City of Austin Residential Permit Application

Master Comment Report

Property: 1010 W Gibson St

Case #: 2026-067749 PR

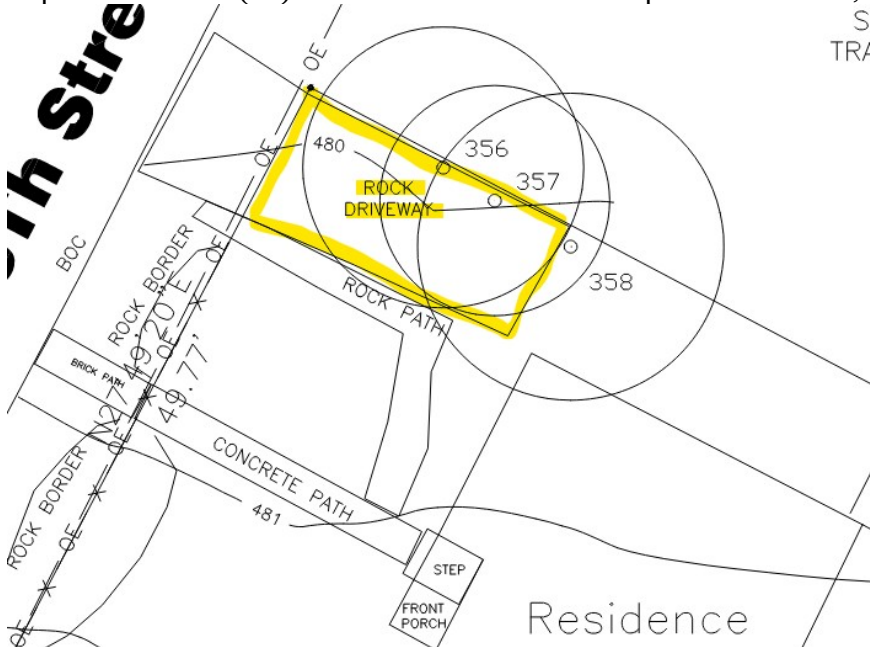
RZ4. Page 2 of the application lists 324.50 sqft for balcony square footage. Page 9 lists 117 sqft for the same space. There are technically 3 balconies in this proposed design (the 2nd cantilevered covered balcony, the 3rd floor balcony and the uncovered roof-top deck). Page 2 includes both the 2nd & 3rd floor balconies but does not include the roof-top deck. Page 9 only shows the 2nd floor balcony.

The roof-top deck measures approx. 564.75 sqft. Please provide your own calculation and include all 3 balconies on both pages of the application.

Pg 2 lists 935 sq ft for the balcony where pg. 9 lists 117 sq ft. Please ensure that pg. 2 and pg. 9 are identical.
